### Permit No: CBL: Issue Date: City of Portland, Maine - Building or Use Permit Application 09-0957 392 A020001 389 Congress Street, 04101 Tel: (207) 874-8703, Fax: (207) 874-8716 Owner Address: Phone: Location of Construction: Owner Name: 207-232-8050 189 HOPE AVE The Vesta Corp / Mike DiMillo P.O. Box 1464 Business Name: Contractor Name: Contractor Address: Phone The Vesta Corp P.O. Box 1464 Portland 2072328050 Phone: Permit Type: Zone: Lessee/Buyer's Name R-2 Single Family **CEO District:** Past Use: Permit Fee: Cost of Work: Proposed Use: \$308,000.00 5 Vacant Land Single Family Home - Build Single \$3,175.00 Family Home 3 bedrooms, 3 bath, FIRE DEPT: INSPECTION: Approved ranch style w/3 car garage ☐ Denied Proposed Project Description: Build Single Family Home 3 bedrooms, 3 bath, ranch style w/ 3 car garage Signature: PEDESTRIAN ACTIVITIES DISTRICT (P.A. Action: Approved Approved w/Conditions Denied Date: Signature: Date Applied For: Permit Taken By: **Zoning Approval** 09/62/2009 Ldobson Special Zone or Reviews **Zoning Appeal Historic Preservation** 1. This permit application does not preclude the Applicant(s) from meeting applicable State and Shoreland Variance ✓ Not in Di

Drawing Name:	Site, Utility, Grading and Drainage Plans
Praject:	Presumpscot River Place Hope Avenue, Portland, Maine
Client:	<b>Vesta Corporation</b> P.O. Box 1464, Portland, ME 04104

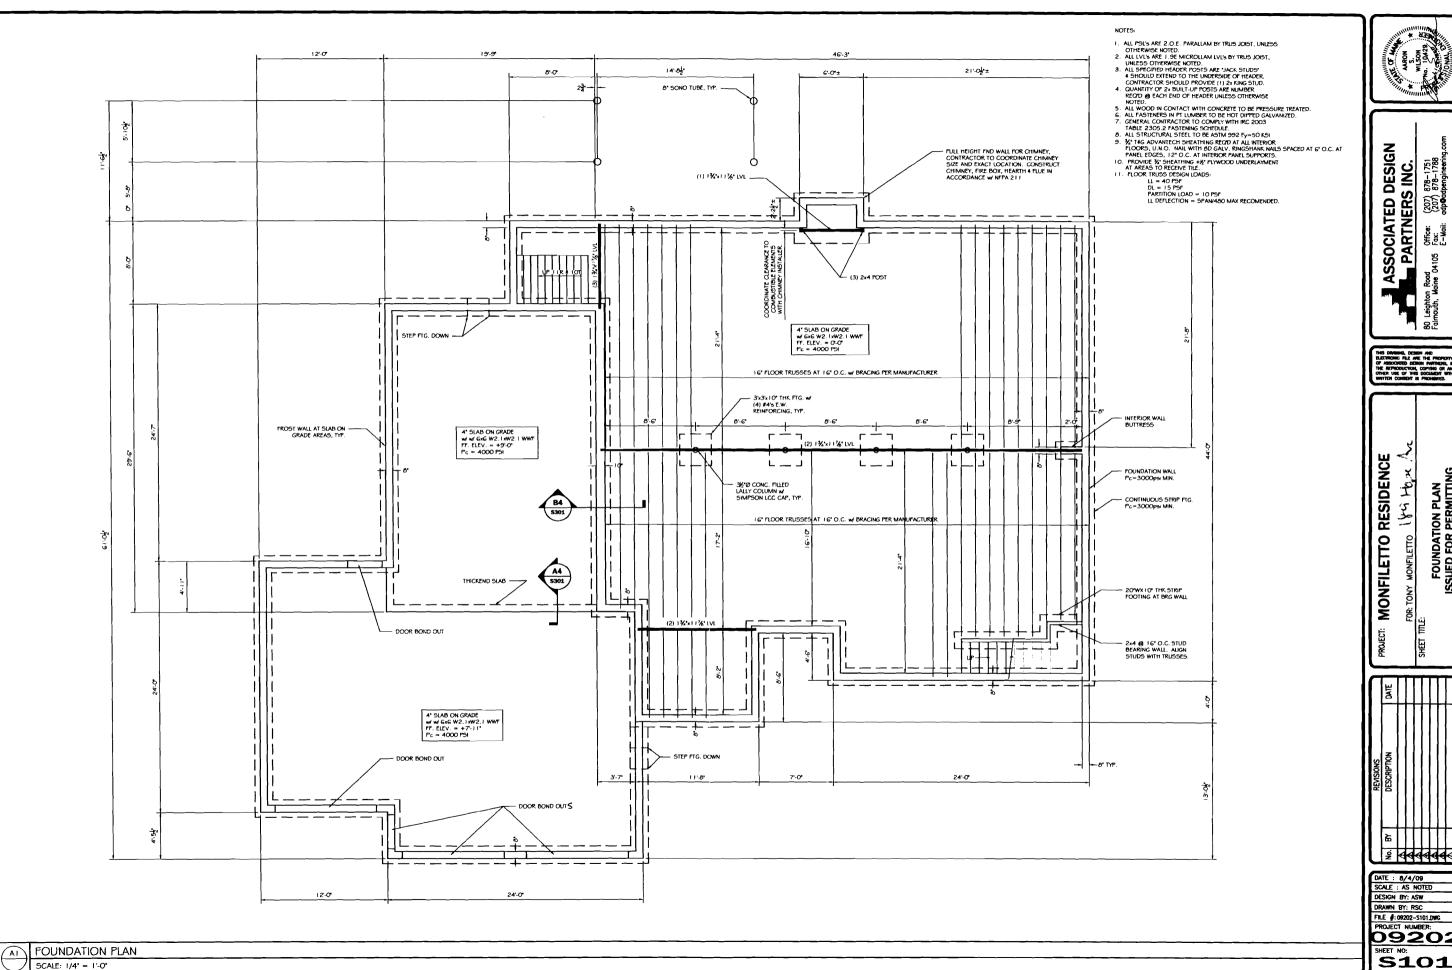
9/16/2009-amachado: Received revised site plan with porch removed.
